1 Products affected

Product Change Notification					Inscription change OGD-SMD			
owner	creation date	release date	released by	change order no	rev	page	D40 040 050	
dislercy	2017-01-23	2017-02-22	nowakfr	2011941	Α	1 of 2	D10-012-850

3 Detailed description of change

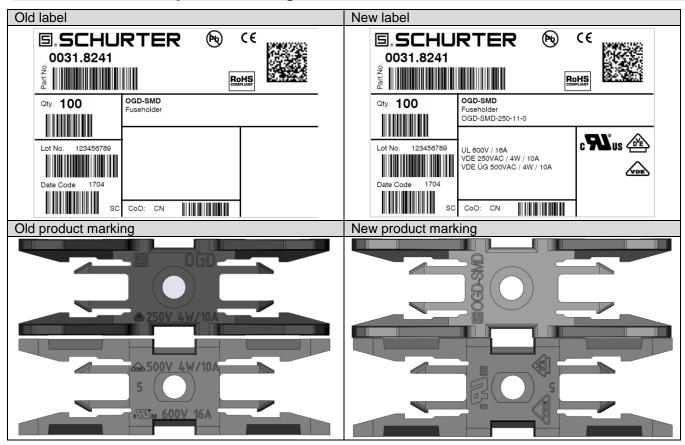
- Modified label
- Change of markings

Form Yes Inscription on socket changed
Fit No No change for dimension
Function No No functional change

Label Yes Approvals and configuration code on label

Adjusted product markings acc. to current standard and approvals.
